| Project | 342-348 Victoria Street, Brunswick 322-0714 | Date | 25 November 2024 |
| Subject | 342-348 Victoria Street, Brunswick – Summary of Changes to Approved Development under MPS/2017/745/E | | |

**Planning Permit No. MPS/2017/745/A
342-348 & 368-370 Victoria Street, 13 & 15 Rosser Street and 32 Wilkinson Street, Brunswick
Request for Further Information (RFI) Response – WSUD Strategy Justification**

Drawing Name
Raingarden Scenario 3

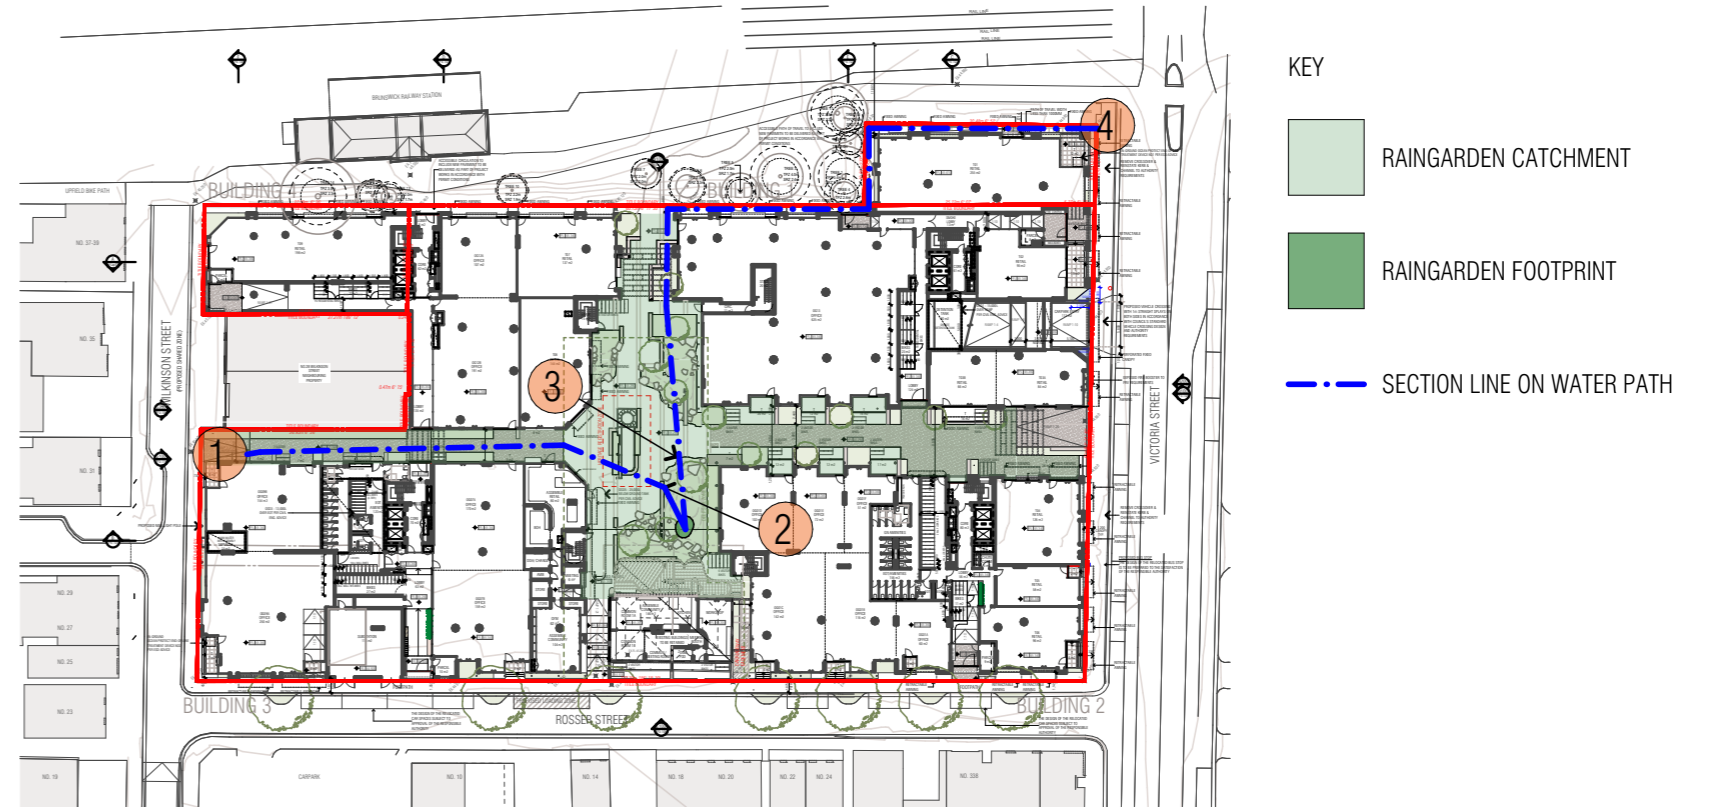
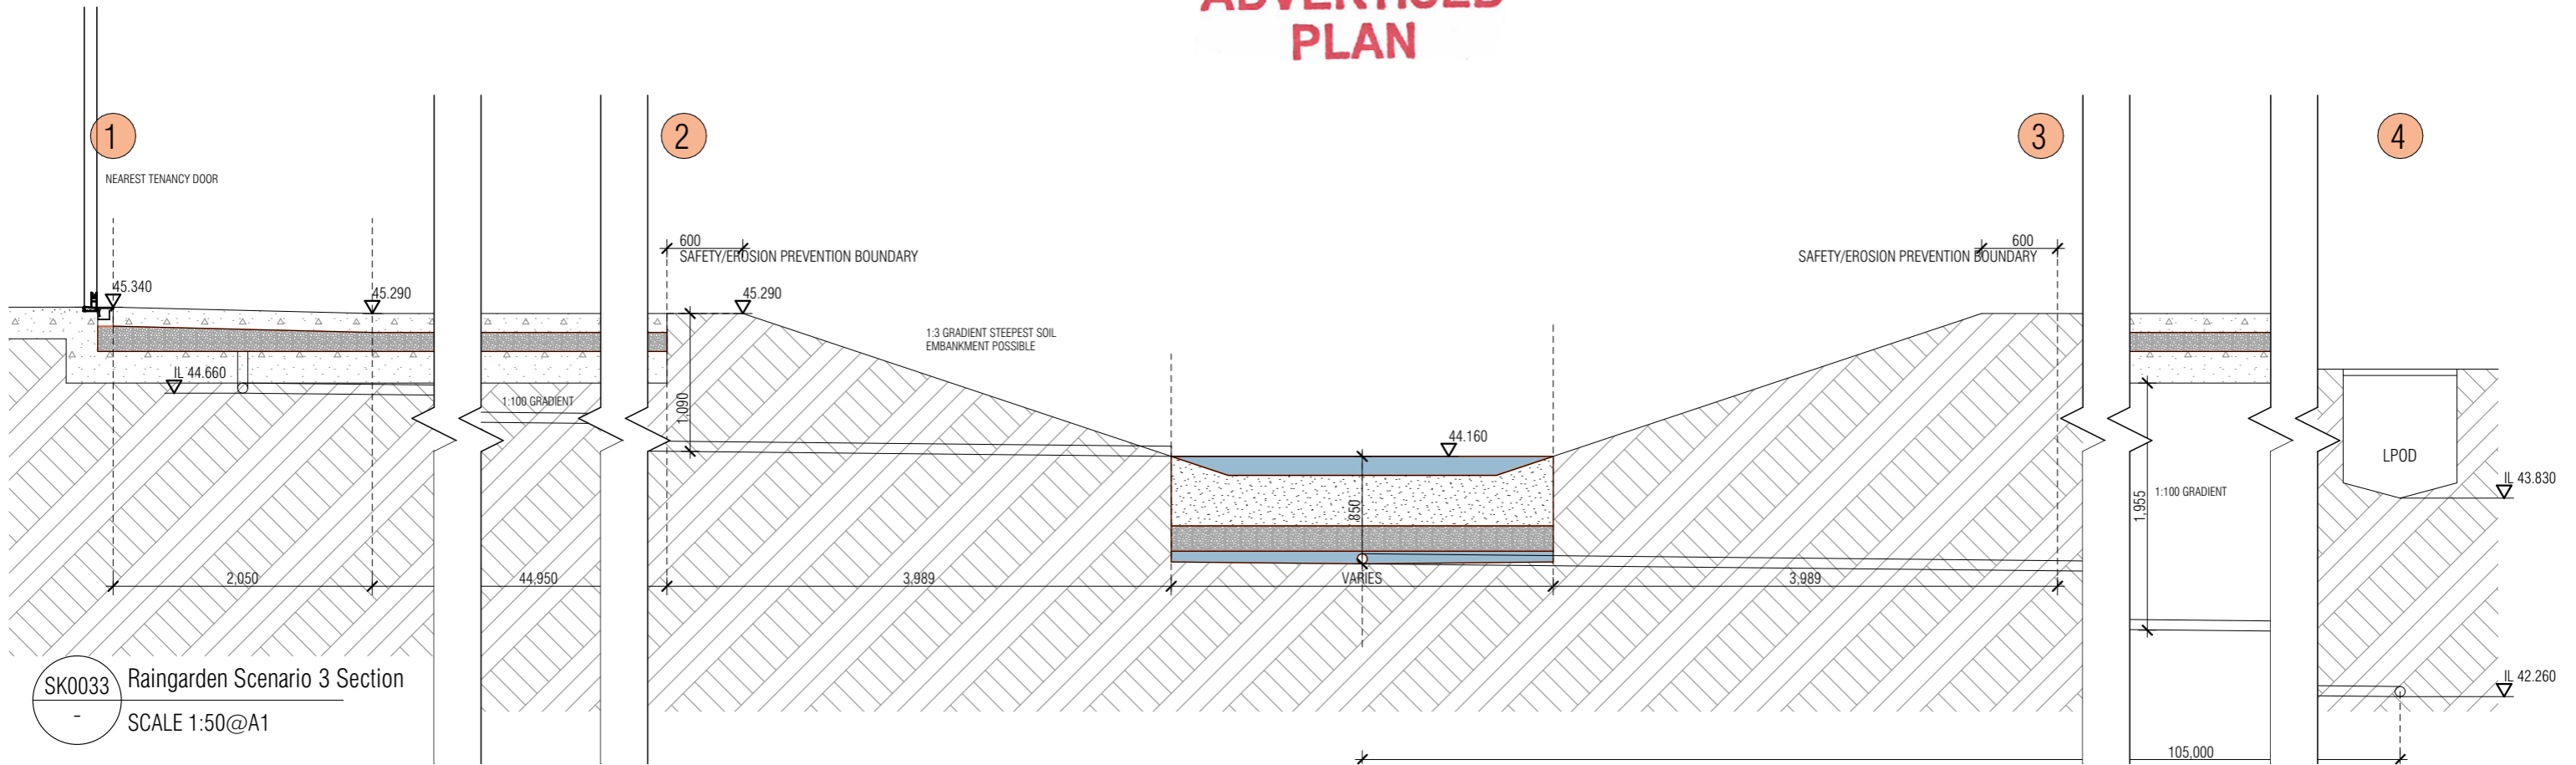
RAINGARDEN SCENARIO 3 OUTLINE

a raingarden catching water from the entire site loses almost all of its functional area to landscaping gradient setbacks, clashes with the basement, ruins a key open space and cannot naturally discharge water to the LDP.

A. In order to provide coverage to the entire site, water is directed to the raingarden via pipework under the structural slab. With a landscape buildup of 300mm, slab thickness of 250mm and a 50mm fall away from building entrances to prevent water ingress, the invert level for the pipe begins 680mm below ground floor RL.

B. The maximum distance from open landscaped areas to the raingarden is 47m, resulting in 470mm of fall to the raingarden, with drainage pipes maintaining a gradient of 1:100. This means that the pipe is 1090mm below the surrounding landscape finish by the time it gets to the edge of the garden.

C. The pipe being 1090mm below landscape levels means that it is an unacceptably deep obstruction in the basement, and would require the basement to be made deeper for this pipe alone, which is not feasible.

D. There cannot be a network of local raingardens, as this would not be possible over the basement in the northern laneway, so the same maximum run would apply. Therefore, an RL of 44.20 to the top of the raingarden is the most optimistic outcome for a raingarden with a full site catchment.

E. With the top level of the raingarden at RL 44.16, the 1.2m of fall can be landscaped at a maximum gradient of 1:3. Any steeper and soil erosion cannot be prevented. A minimum flat soil width at the top of the slope of 500mm is necessary for soil stability, and 600mm has been allowed for as this is a recommended margin to prevent vision impaired people who wander off the path from falling in the ditch. These parameters generate a 4m setback from the edge of the landscaped area to the section of the garden that can perform as a raingarden. The resulting area that can filter water is of too small an area to process the water this catchment would provide.

F. Because of the levels and gradients, this large garden would no longer function as an active play space for children, as it would present as a ditch rather than a garden. The site would be losing a key communal open space and gaining a stormwater asset.

G. Downstream from the raingarden, at a gradient of 1:100, the drainage pipe would arrive at the location of the Legal Point of Discharge at an RL significantly lower than the LPD. This could be overcome with a tank and pump, although this is not a recommended raingarden design feature.

H. The downstream pipe needs to cross the basement, and does so at a level that is an unacceptably deep obstruction in the basement, and would require the basement to be made deeper for this pipe alone, which is not feasible. The LPD could be moved to the corner of Rosser St and Victoria St to avoid this, but the LPD is shallower again.
